RHODE ISLAND DEPARTMENT OF TRANSPORTATION

RHODE ISLAND CONTRACT NO.2014-CT-015

RI*STARS - Aquidneck Island - America's Cup Avenue and Memorial Boulevard Improvements (HSIP Funds)

ADDENDUM NO. 1 Prospective bidders and all concerned are hereby notified of the following changes in the Plans, Specifications, Proposal and Distribution of Quantities for this contract. These changes shall be incorporated in the Plans, Specifications, Proposal and Distribution of Quantities, and shall become an integral part of the Contract Documents.

3. Sheet 9 - Miscellaneous Details - 3

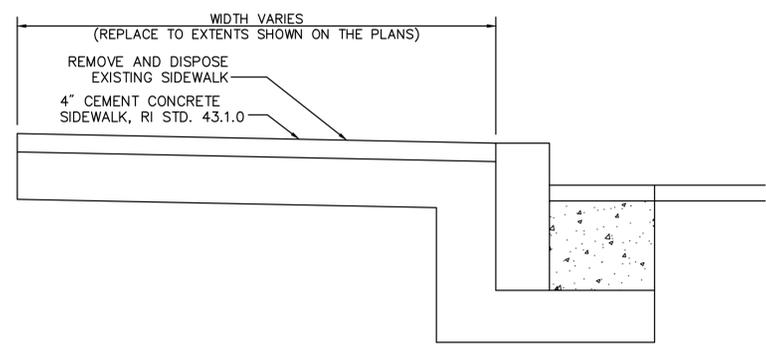
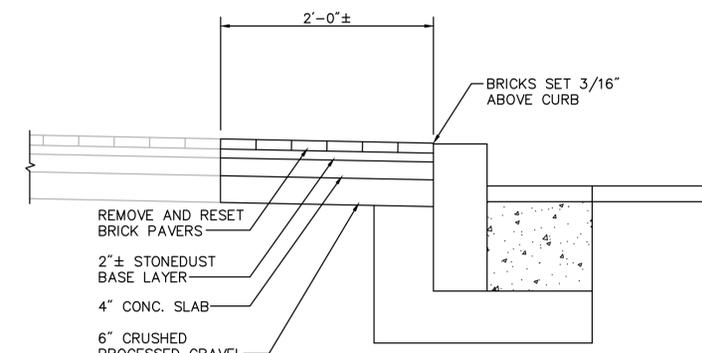
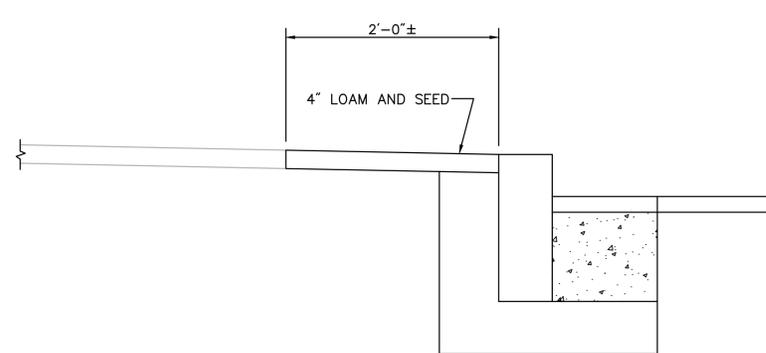
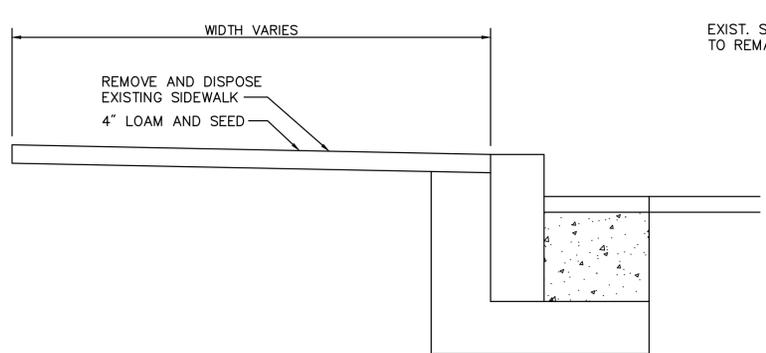
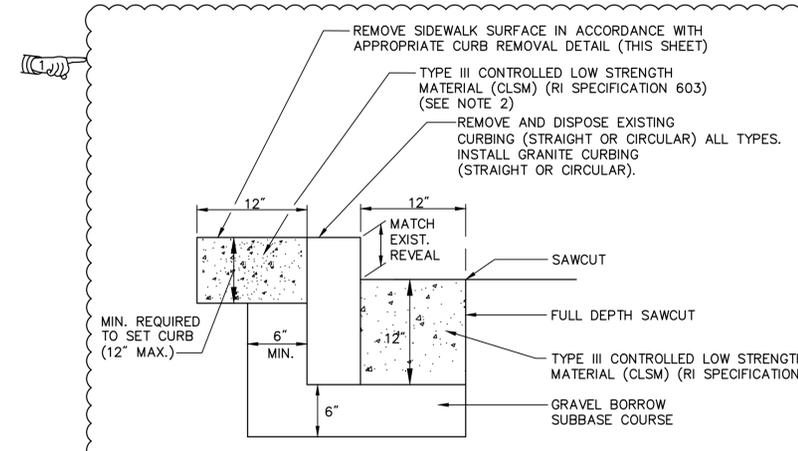
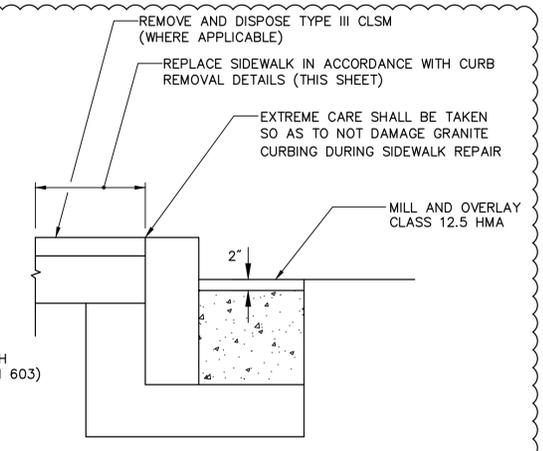
Delete Plan Sheet 9 in its entirety and replace it with Plan Sheet 9(R-1) attached to this Addendum No. 1. A detail has been added.

TRAFFIC SIGNAL PLAN - 1
 AMERICA'S CUP AVE AT BRIDGE ST

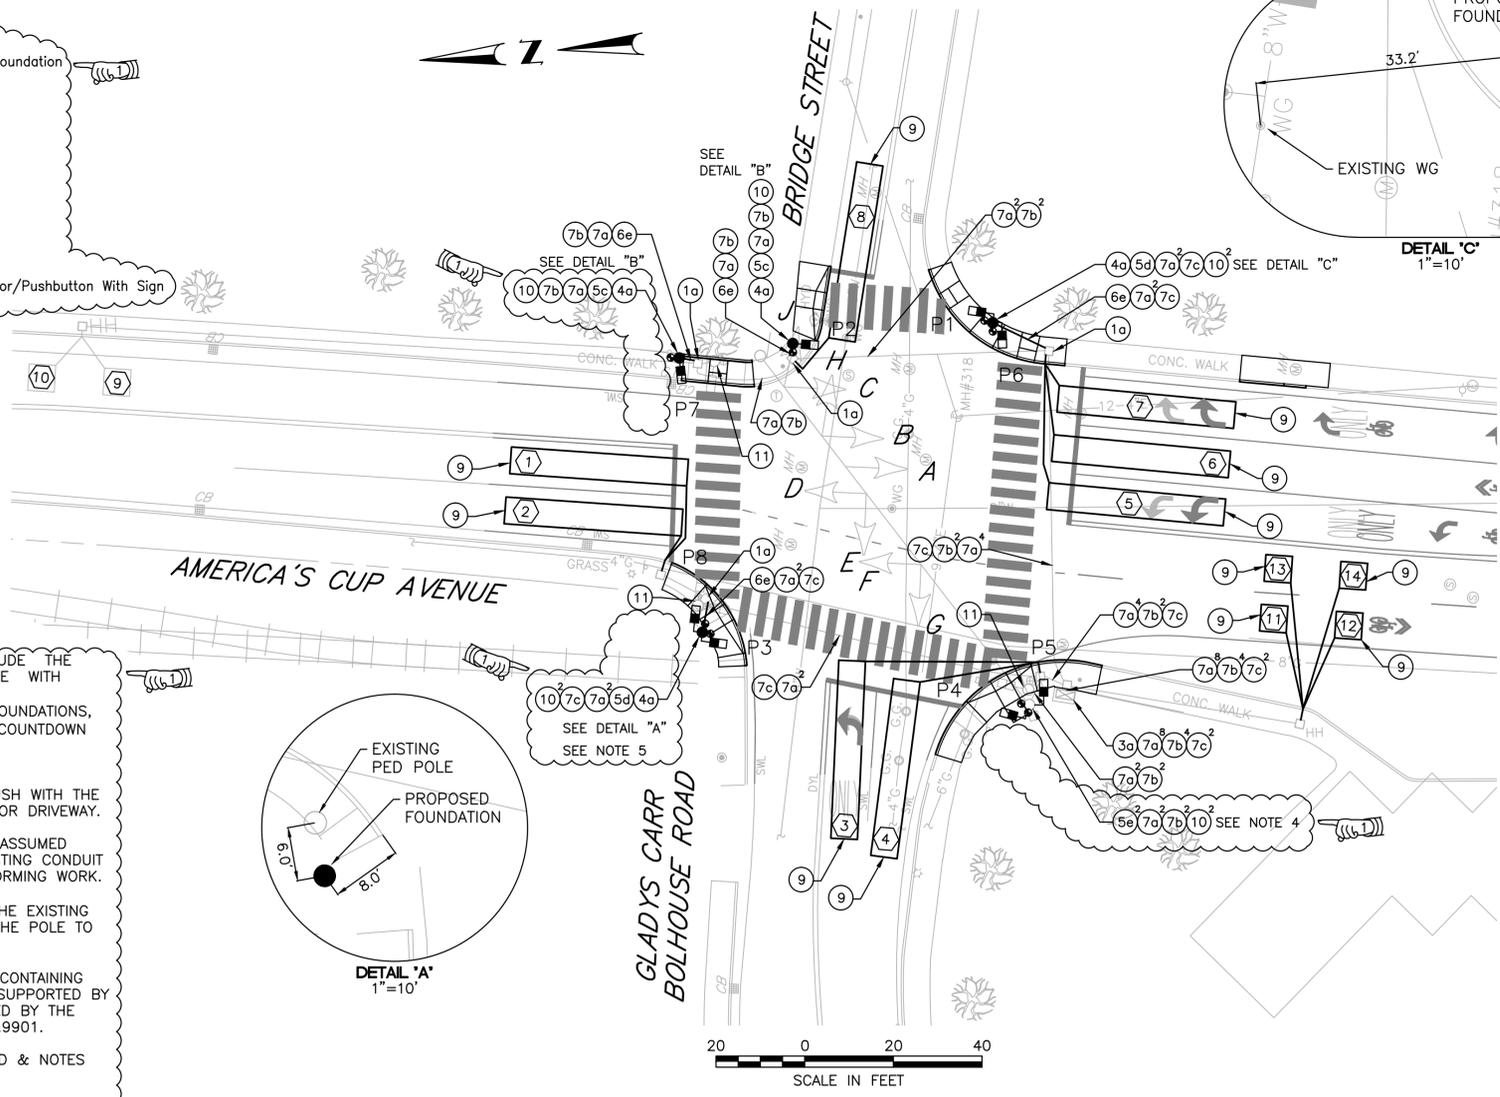
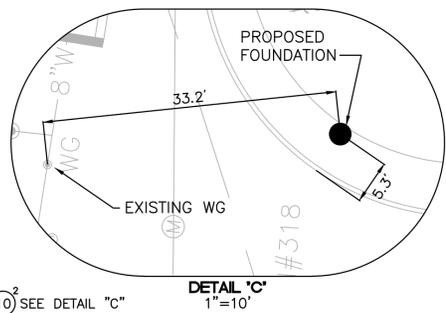
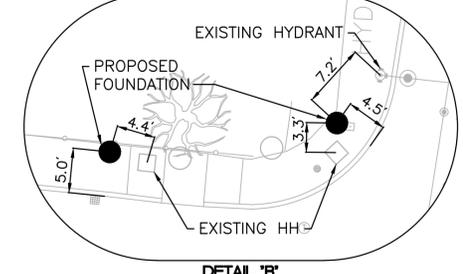
Delete Plan Sheets 40 through 45 in their entirety and replace them with Plan Sheets 40(R-1) through 45(R-1) attached to this Addendum No. 1. Callouts have been revised.
